Access Compliance Report

Public Rights-of-Way

(Curb Ramps)

Intersection ID: 18909	Main Street: CLARENDON_RD	Cross Street: COLONY_RD	Location: W
ADA ID: 0C3FC5338CD3	Ramp Type: PerpDiag	Initial Pass/Fail: Fail	Overall Compliance: No
Severity Score: 13.75			
Codes/Mitigation Info/Possible Solution		Field Measurements/Component Compliance

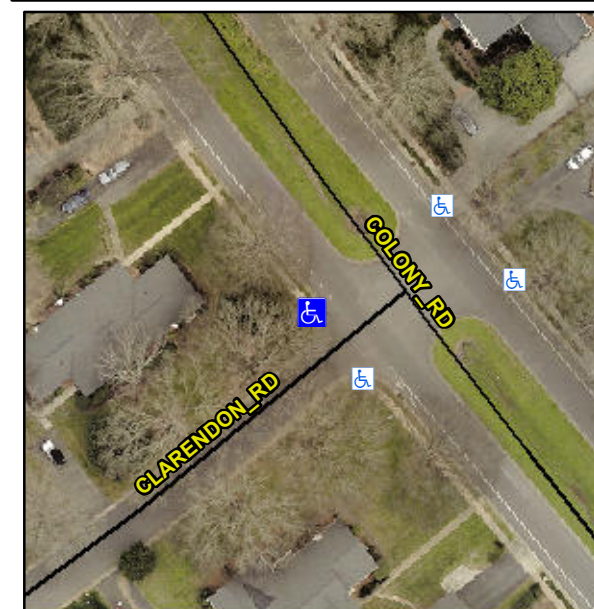
Not Found, R304.2.2, R304.5.3

Compliance	Description	Data	Compliance	Description	Data
N/A	Ramp Length (in)	66.0	No	Ramp Slope (%)	9.2
Yes	Ramp Width (in)	48.0	No	Ramp XSlope (%)	2.1
N/A	Flare Type LT	N/A	N/A	Flare Type RT	N/A
N/A	Flare Slope LT (%)	N/A	N/A	Flare Slope RT (%)	N/A
N/A	Flare Traversable LT?	N/A	N/A	Flare Traversable RT?	N/A
N/A	Landing Length (in)	N/A	N/A	DWS Provided?	N/A
N/A	Landing Width (in)	N/A	N/A	DWS Contrast?	N/A
N/A	Landing Slope (%)	N/A	N/A	DWS Length (in)	N/A
N/A	Landing X Slope (%)	N/A	N/A	DWS Full Width?	N/A
N/A	Landing Curb? (Y/N)	N/A	N/A	DWS Offset (in)	N/A
N/A	Shared Landing?	N/A			
N/A	Gutter Ponding?	N/A	N/A	Gutter Slope (%)	N/A
N/A	Gutter Lip Ht (in)	N/A	N/A	Gutter X Slope (%)	N/A
N/A	Painted X Walk1?	No	N/A	Painted X Walk2?	No
	X Walk 1 Direction	To SE		X Walk 2 Direction	To E
N/A	X Walk 1 Width (in)	N/A	N/A	X Walk 2 Width (in)	N/A
	X Walk 1 Slope (%)	5.1		X Walk 2 Slope (%)	10.2
	X Walk 1 X Slope (%)	5.0		X Walk 2 X Slope (%)	4.3

Remove & Replace Curb Ramp With Two New Directional Ramps or Equivalent.
